Enclosure 2  
Meeting Summary Handouts  
of the May 4, 2011  
ROP Public Meeting  
Dated June 06, 2011

## REACTOR OVERSIGHT PROCESS (ROP) MONTHLY PUBLIC MEETING AGENDA

## ROP Task Force Comments on April 1 Draft Revision of NRC's Inspection Manual Chapter 0608, "Performance Indicator Program"

Figure F-6

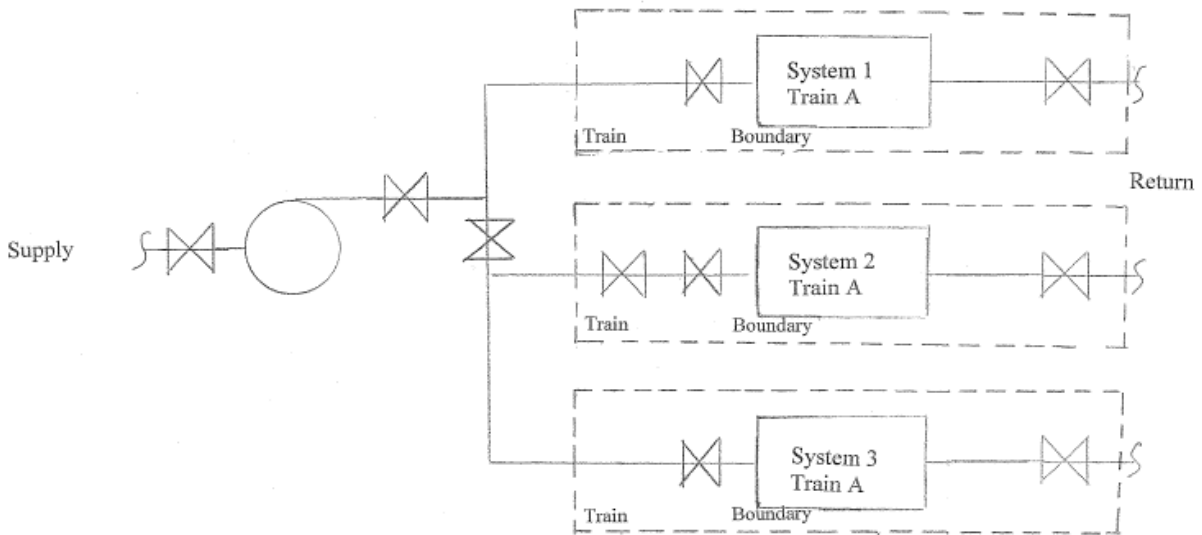
NEI 99-02, Rev. 6, provides guidance for the cooling water system scope on pages F-52 and F-53. The text from page F-53, lines 2 through 7, highlighted in italics below, indicates that only the last valve in a cooling water system line is included in the boundary of the monitored component. While this may be correct in most applications, there are plant configurations where a cooling water system line running to a monitored system (EDG for example) has more than one isolation valve (e.g., manual isolation valve(s)). If the isolation valve(s) were closed it would only result in supported train unavailability and would not affect the availability of the cooling water system. However, the guidance on page F-53, lines 2 through 7, could lead one to the opposite conclusion and suggest that the cooling water system would be unavailable.

Question - Should a cooling water system isolation valve(s) in a line supplying a single monitored component be included in the monitored train's system boundary?

Response – Yes, a cooling water system isolation valve(s) in a line supplying a single monitored train should be included in the monitored train's system boundary.

Revise NEI 99-02, Rev. 6, Page F-53, lines 1 through 9, to read as follows:

Systems that provide this function typically include service water and component cooling water or their cooling water equivalents. Pumps, valves, heat exchangers and line segments that are

necessary to provide cooling to the other monitored systems-trains or segments are included in the cooling water system scope up to, but not including, the last isolation valve(s) that connect(s) the cooling water support system to components in a single monitored system train or segment. This/these last isolation valve is/are included in the other-monitored system-train or segment boundary. If theThe last valve(s) that provides cooling to SSCs in more than one monitored system or traintrain or segment, then it is included in the cooling water support system. If the cooling water line to a single monitored component or train contains componentsAll valves (e.g., manual isolation valves or motor operated valves (MOVs))-that would only affect the monitored component or train, those components in a cooling water line to a single monitored train or segment -are included in the -other systemmonitored train or segment boundary. Figure F-4-6 depicts the treatment of multiple isolation valves. Service water systems are typically open “raw water” systems that use natural sources of water such as rivers, lakes or oceans. Component Cooling Water systems are typically closed “clean water” systems.

Page F-19, Table 2

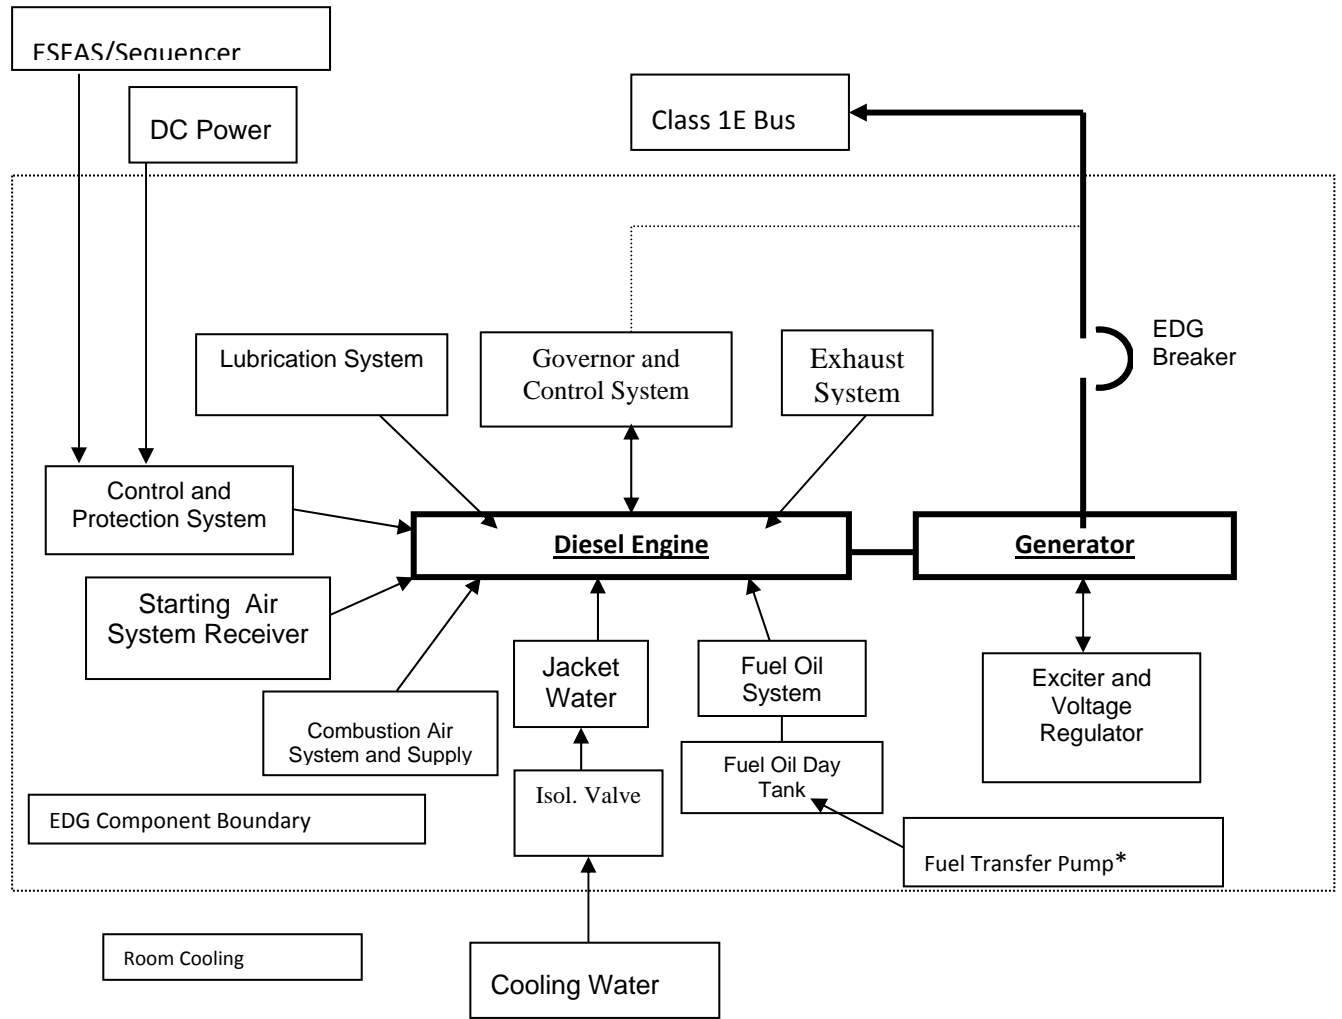
NEI 99-02 section F.5 page F-45 provides inconsistent treatment of EDG Fuel Oil Transfer pumps (FOTPs). The FOTPs are identified as being within the system boundary but are not monitored components nor do they contribute to the unavailability unless there is only one pump per EDG. As noted in the guidance, the reason for this treatment is that the FOTP contribution to MSPI was expected to be small. Additional investigation has shown that for some plant configurations, the contribution from the FOTPs could be significant, based on plant design details such as number of pumps, number of EDGs, Day Tank Capacity, cross connect capability, etc. Therefore, appropriate consideration of the FOTPs in MSPI is needed.

Revise NEI 99-02 section F.5 and Figure F-1 to include the Fuel Oil Transfer Pumps within the EDG super-component boundary.

**Licensee proposed wording changes:**

**Bolded and underlined phrases indicate proposed changes**, strike-throughs indicate deletions.

The diesel generator boundary includes the generator body, generator actuator, lubrication system (local), fuel system (local), ***fuel oil transfer pumps***, cooling components (local), startup air system receiver, exhaust and combustion air system, dedicated diesel battery (which is not part of the normal DC distribution system), individual diesel generator control system, cooling water isolation valves, circuit breaker for supply to safeguard buses and their associated control circuit (relay contacts for normally auto actuated components, control board switches for normally operator actuated components)
